HARTZELL PROPELLER INC.
SERVICE BULLETIN
TRANSMITTAL SHEET
HC-SB-61-287

**Propeller - E10950 Blade Inspection, Rework, and Thrust
Bearing Replacement**

This page transmits a revision to Service Bulletin HC-SB-61-287.

**Optical Comparator Overlay GT-3669, Rev. A
Figure 3**

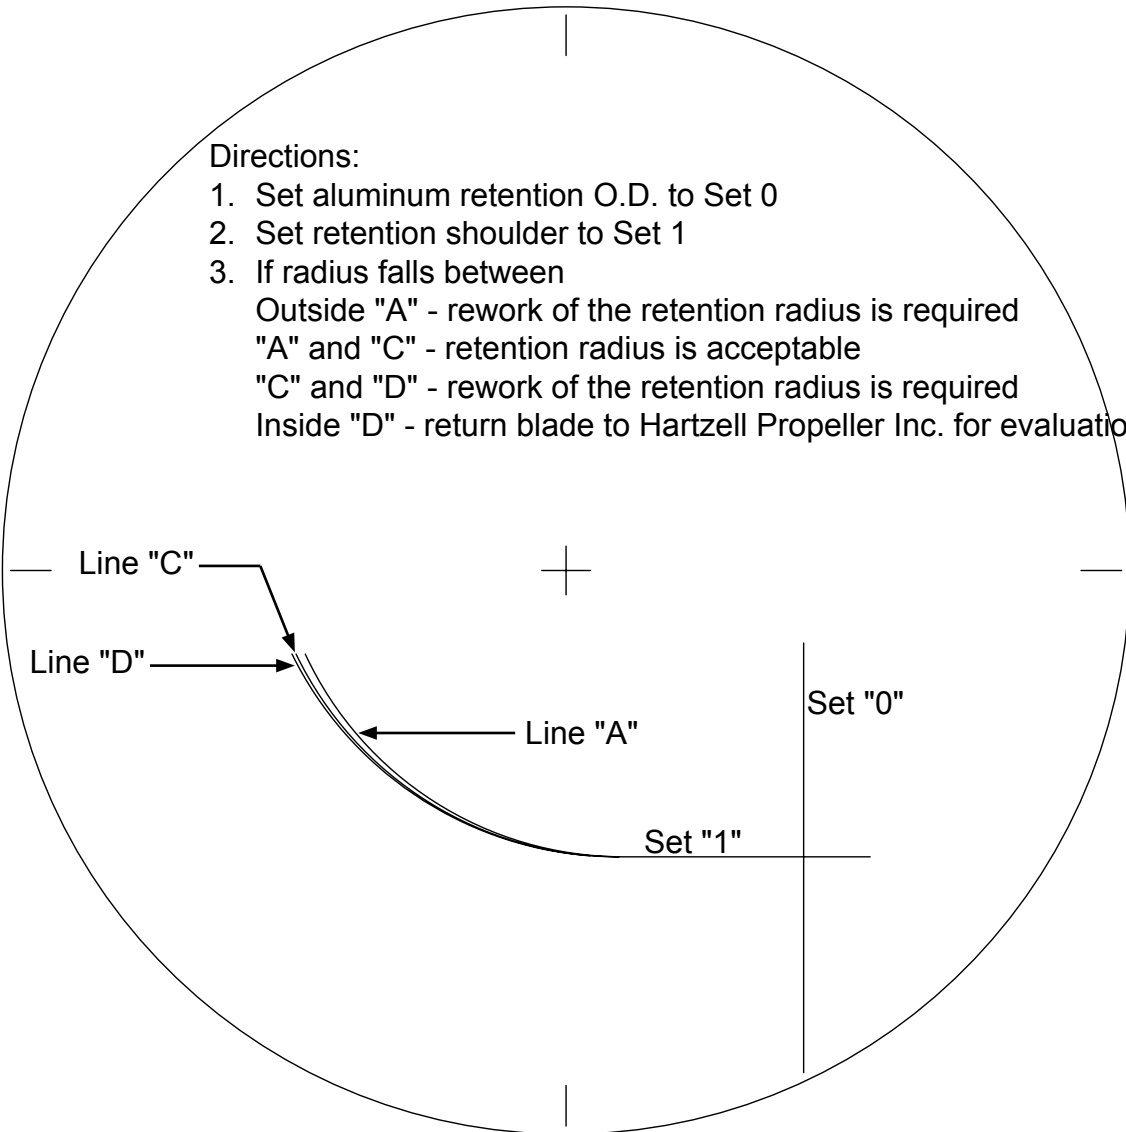
- Adds CAUTION for use of most current revision.
- Changes the compliance interval to 4,000 hours.
- Updates reporting requirements.
- Updates Figure 3 for latest revision of the overlay.
- Clarifies machining instructions for blades with the Delrin® seal installed.
- Clarifies requirement for shoulder height inspection following rework.
- Deletes the Appendix.

- (a) Determine serviceability/repairability by comparing the projected image with the overlay. Make sure that the projected image is within the "A" and "D" lines. See Figure 3.

- 1 If projection is outside line "A", rework the retention radius in accordance with Paragraph 3.D. of this Service Bulletin.

- 2 If projection is between lines "A" and "C" retention radius is acceptable.

- 3 If projection is between lines "C" and "D", rework retention radius in accordance with Paragraph 3.D. of this Service Bulletin.

- 4 If projection is inside line "D", retention radius laminate repair is required. Return the blade to Hartzell Propeller Inc. for evaluation.
